February 12, 2025

Town of Parker
Public Works Department
20120 E. Mainstreet
Parker, Colorado 80138

**Subject: Horse Creek Commercial
Lot 10B, Douglas 234 Filing No. 6, Amendment 2
Drainage Conformance Letter**

**FIGURE 5.1
RAINFALL INTENSITY VERSUS DURATION CURVES FOR PARKER, COLORADO**

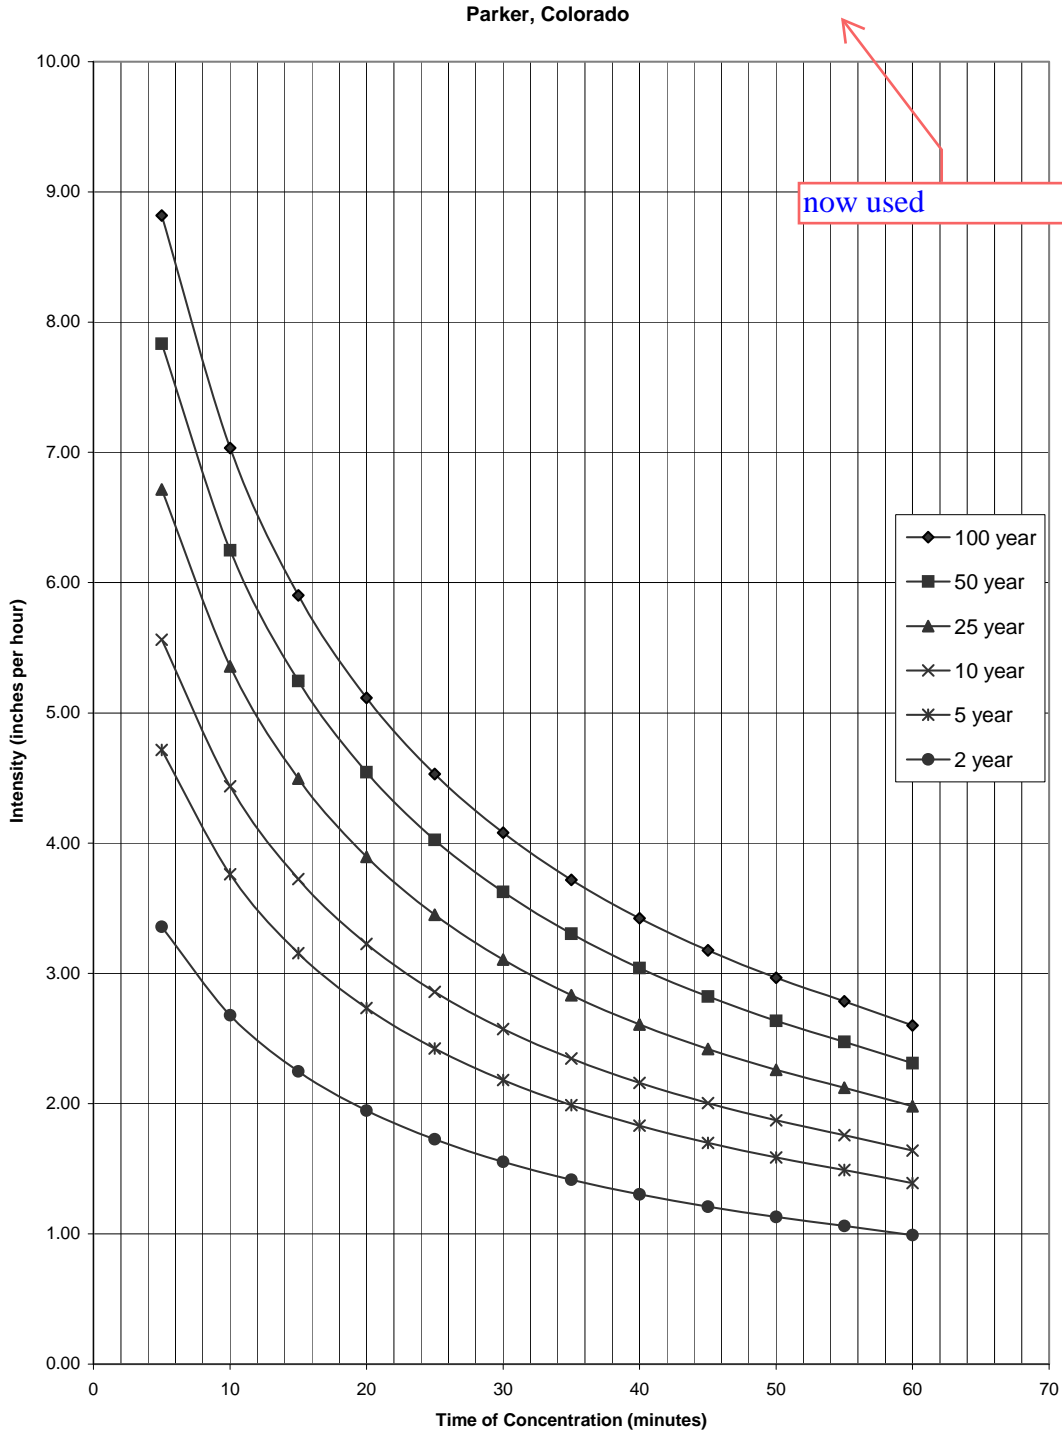
Please use latest NOAA Atlas 14 point rainfall values for Town of Parker in Hydrology calculations and provide reference to the data used in this report. Parker is in the process of updating the SDECM to reflect this in requirement.

INLET IN A SUMP OR SAG LOCATION

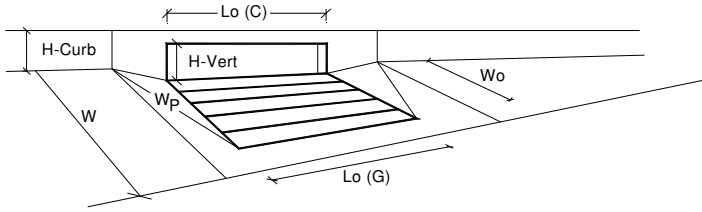
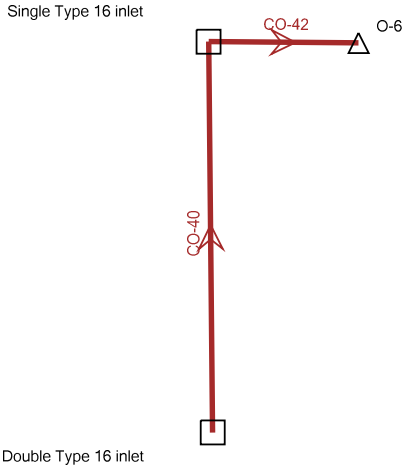
Please include the Initial Sheet for inlet capacity/spread calcs showing assigned flows for the minor and major storm events and bypass flows.

sheet has been added
